SUBJECT: PLANS AND PROPOSAL ADDENDUMS

PROJECT: C 254-7-8

CONTROL: 0254-07-008

PROPOSAL ADDENDUMS

CONT	SECT	JOB	HIGHWAY
0254	07	008, ETC.	US 281
DIST	COUNTY	SHEET NO.	
CRP	JIM WELLS	0016

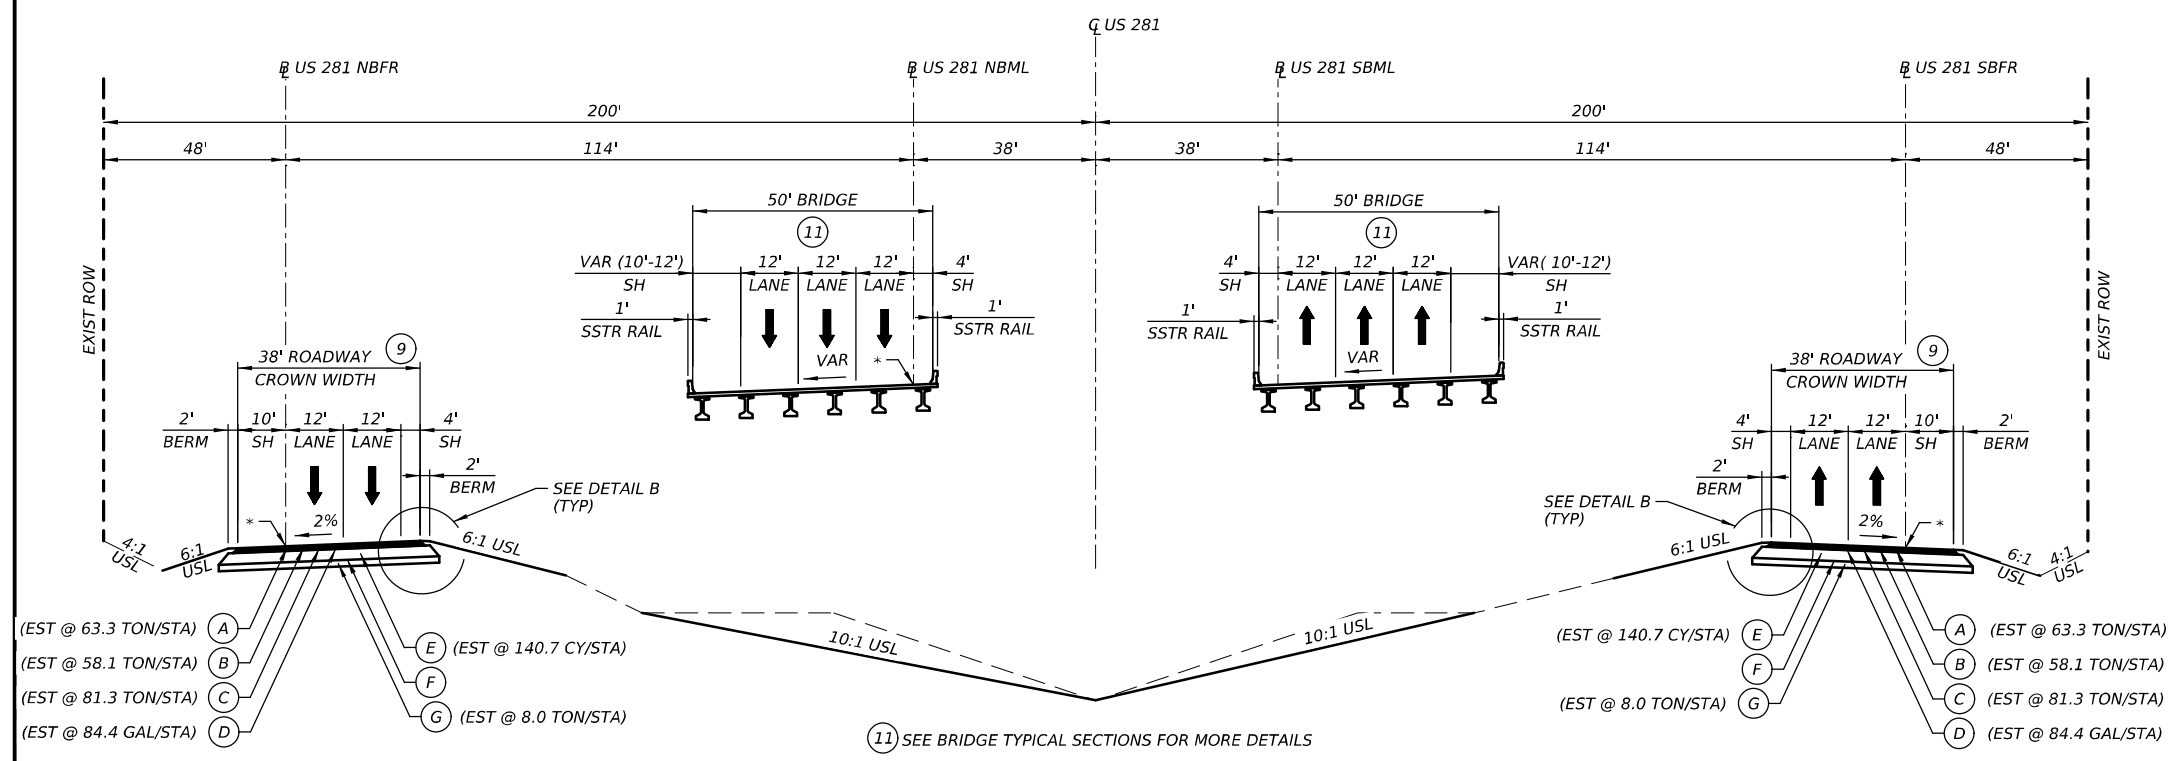
SHEETS 14-24 (PROPOSED TYPICAL SECTIONS): REVISED LEGEND

01	05/2023	PROPOSED SUBGRADE MATERIAL REVISED	
NO.	DATE	REVISION	APPROV.

CONT	SECT	JOB	HIGHWAY
0254	07	008, ETC.	US 281
DIST	COUNTY		SHEET NO.
CRP	JIM WELLS		0017

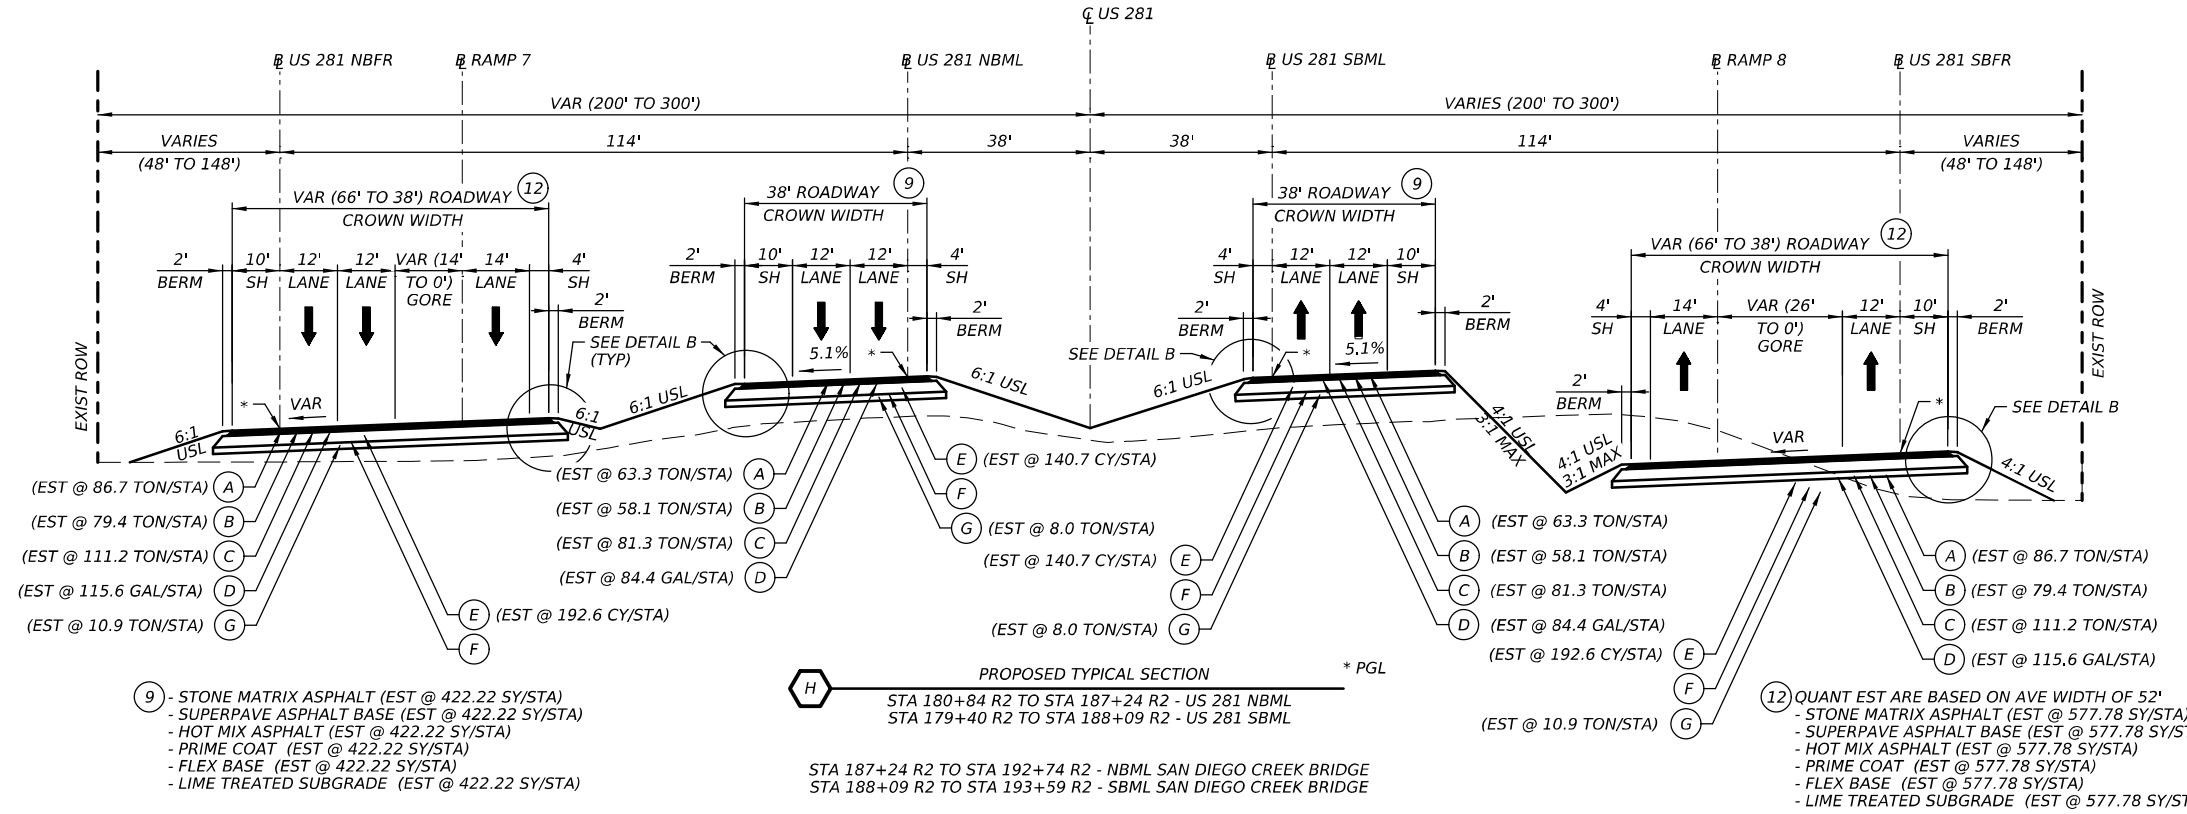
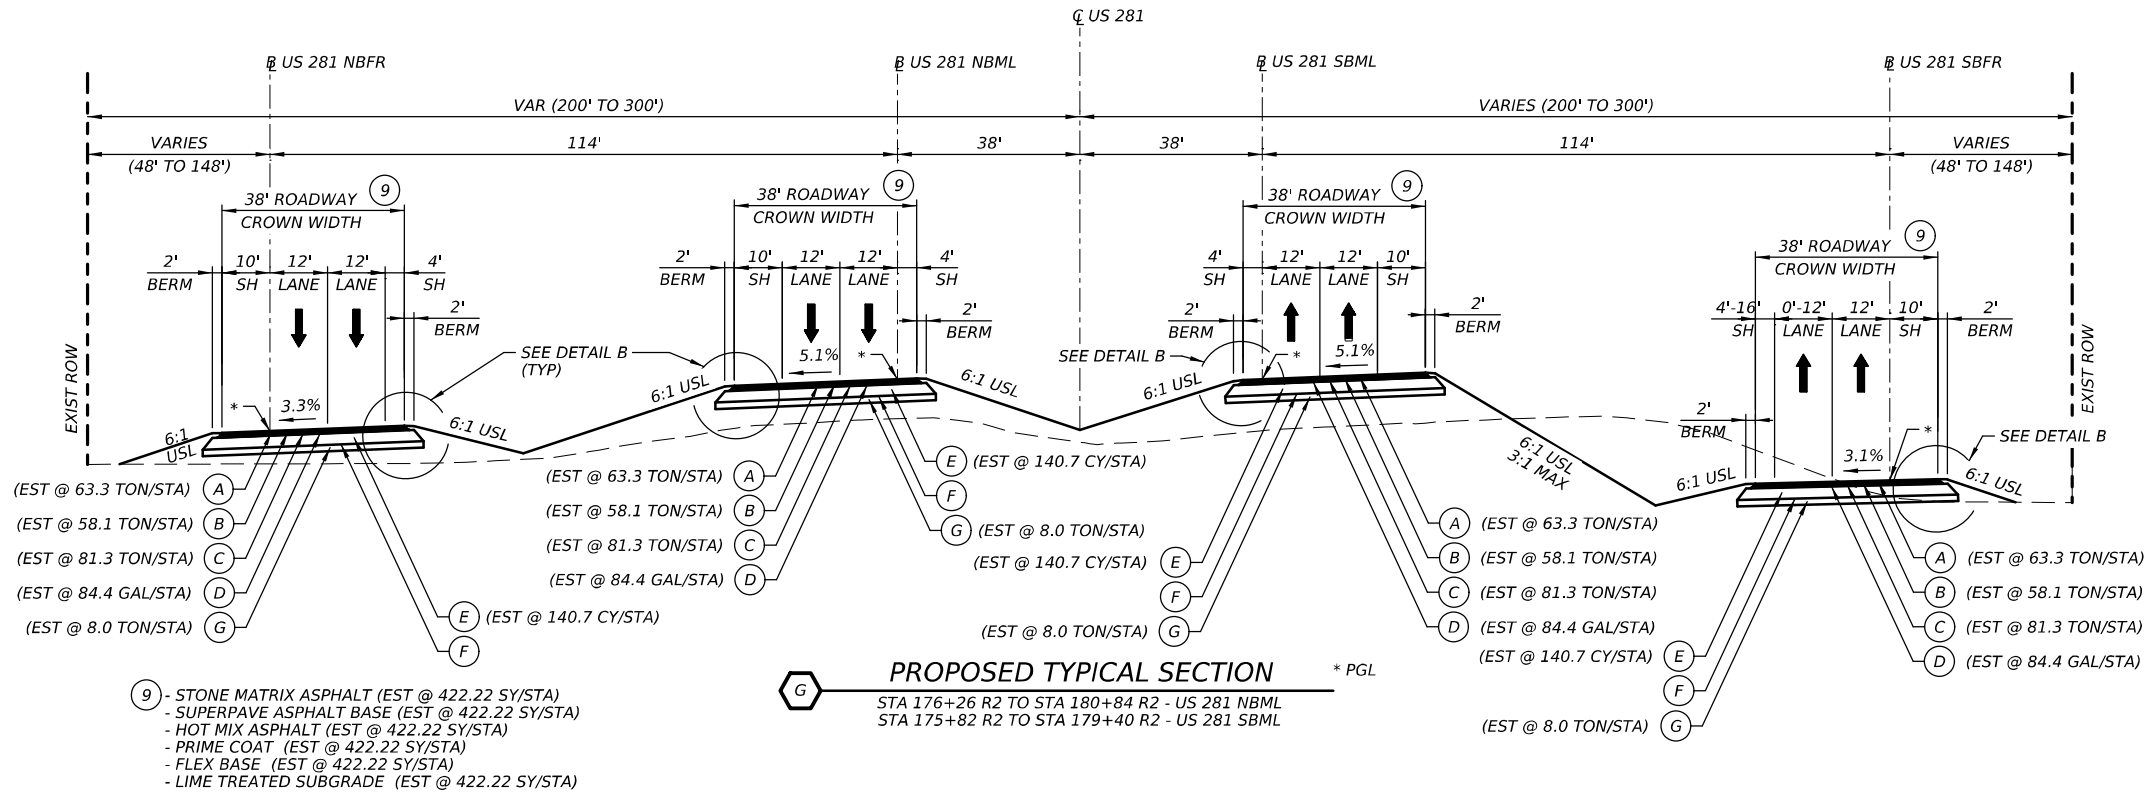
01	05/2023	PROPOSED SUBGRADE MATERIAL REVISED	
NO.	DATE	REVISION	APPROV.

CONT	SECT	JOB	HIGHWAY
0254	07	008, ETC	US 281
DIST	COUNTY	SHEET NO.	
CRP	JIM WELLS	0021

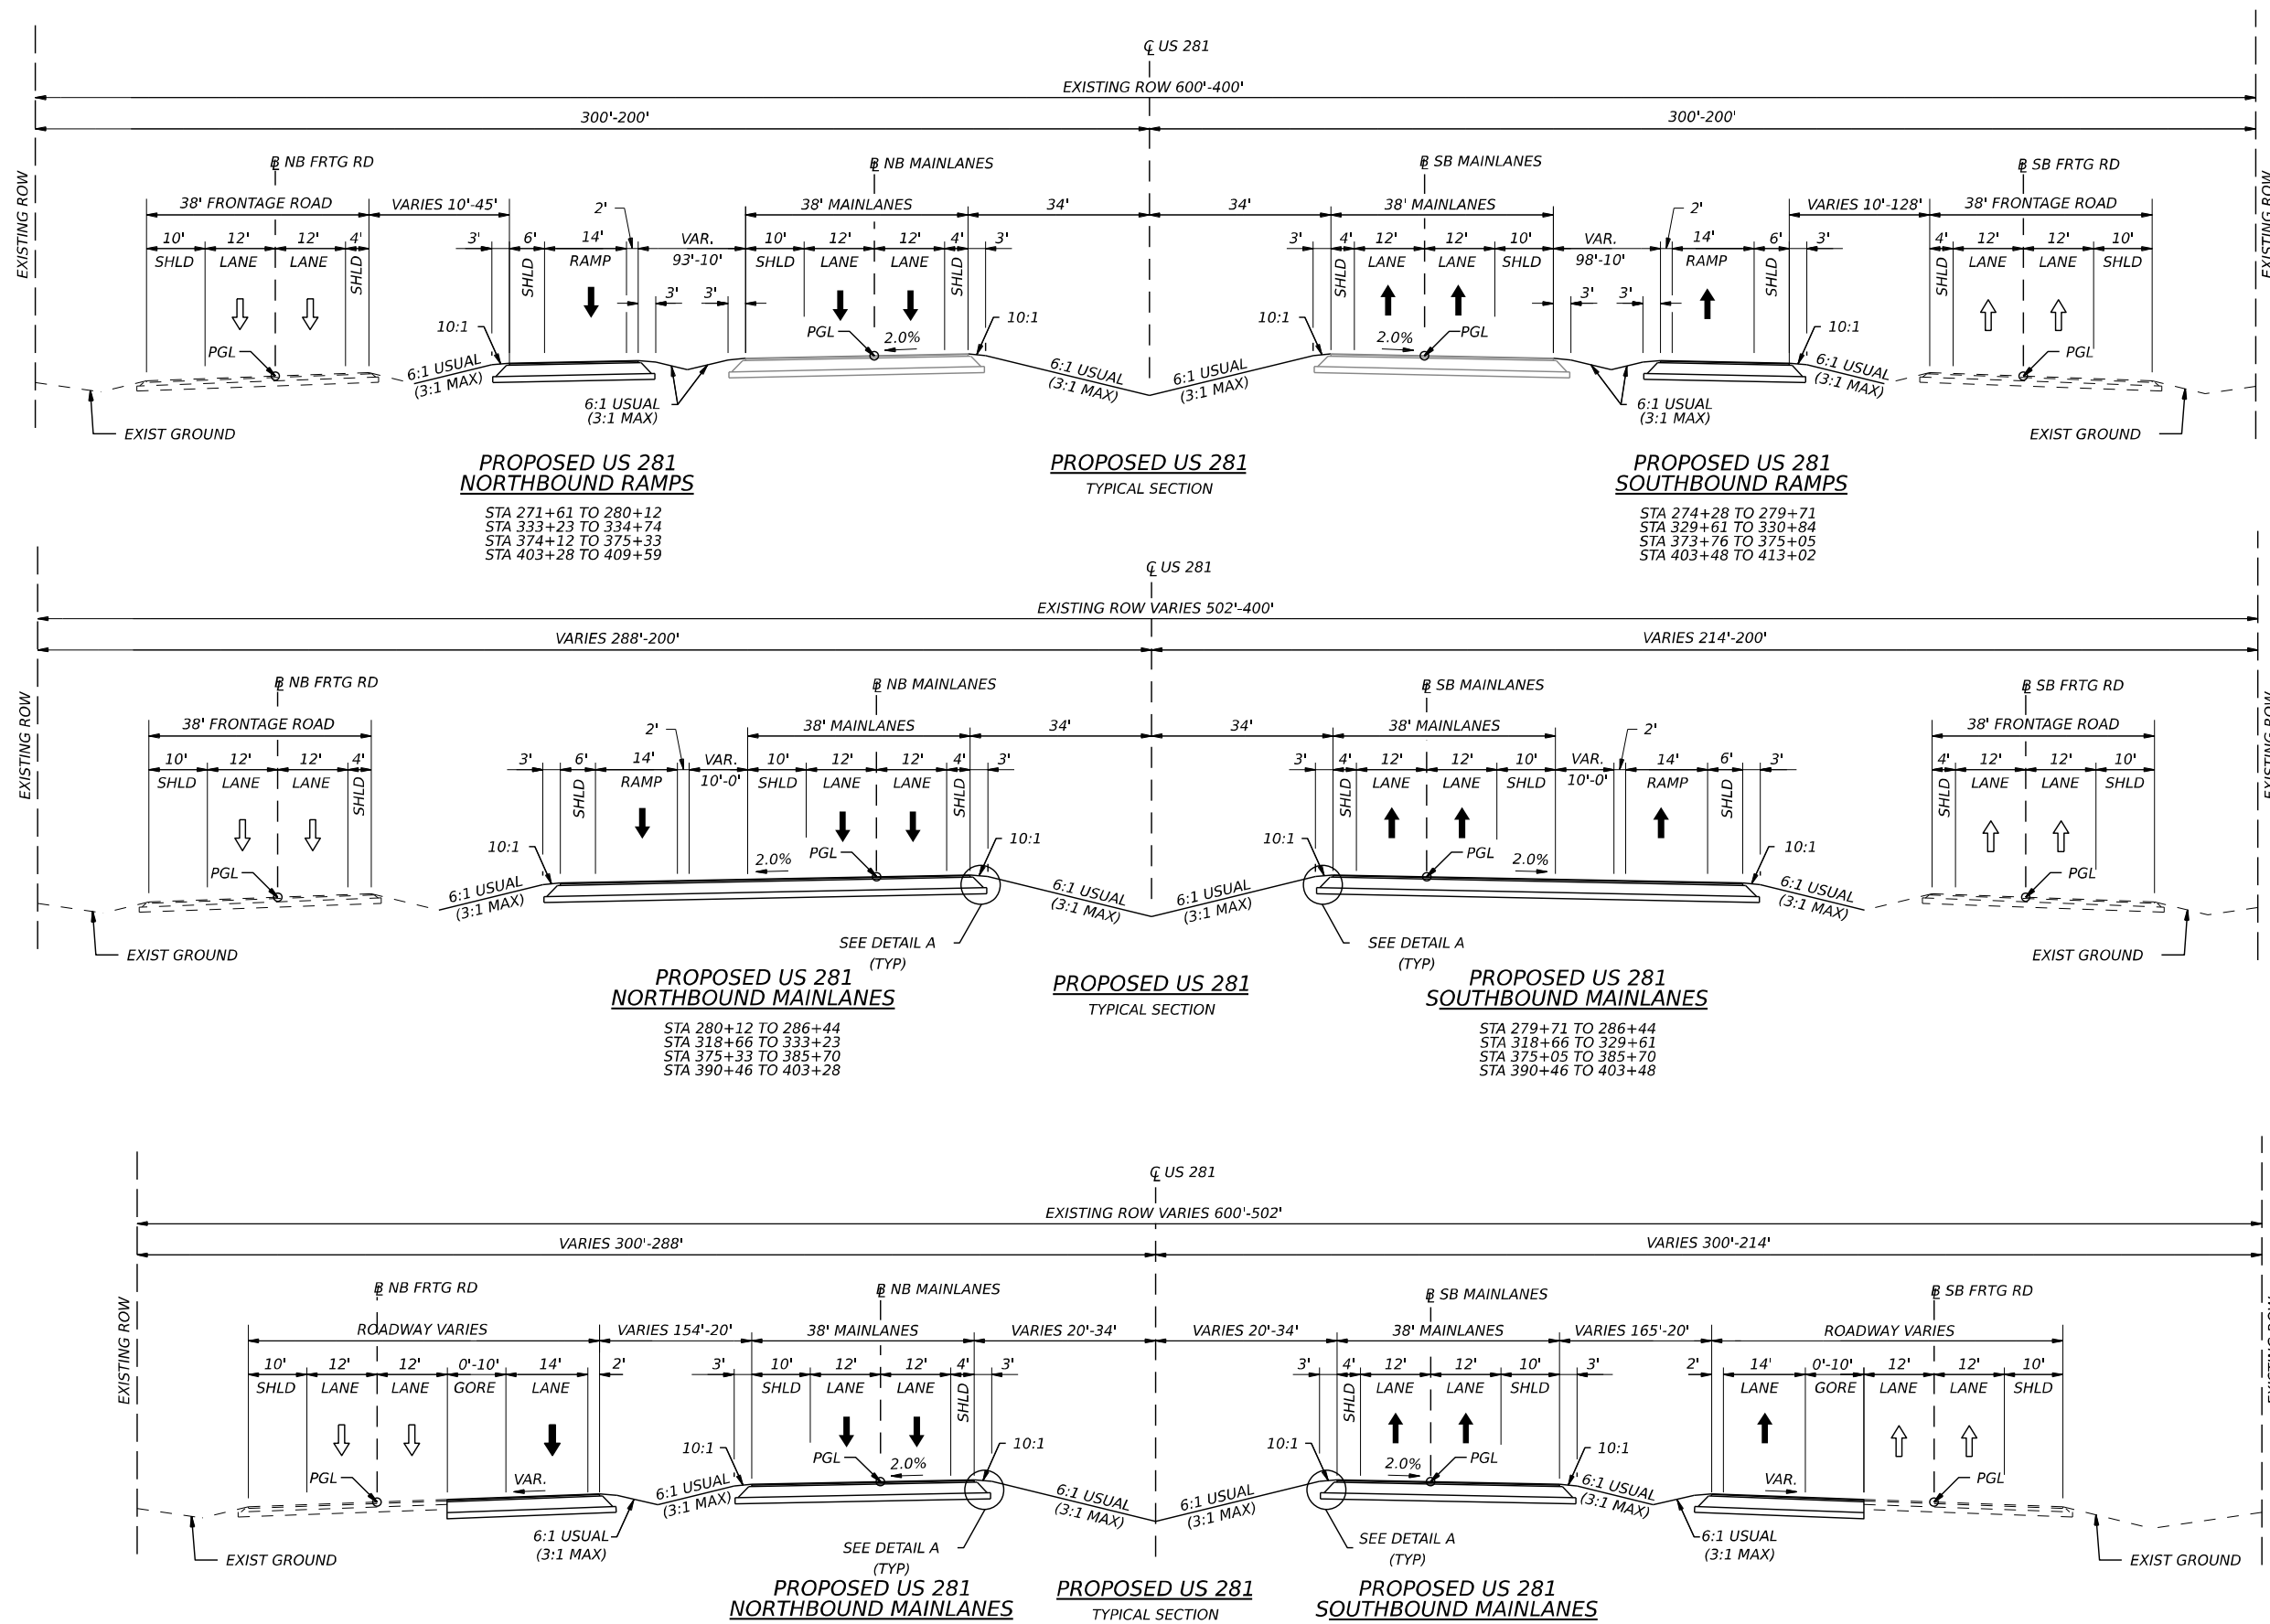
RET WALL 1-4 ARE FROM STA 342+35 TO 369+65.
 SEE SHEET "US 281 OVER CR 129 RETAINING WALL LAYOUT" FOR TYPICAL SECTION
 REVISED SHEET 5/18/2023
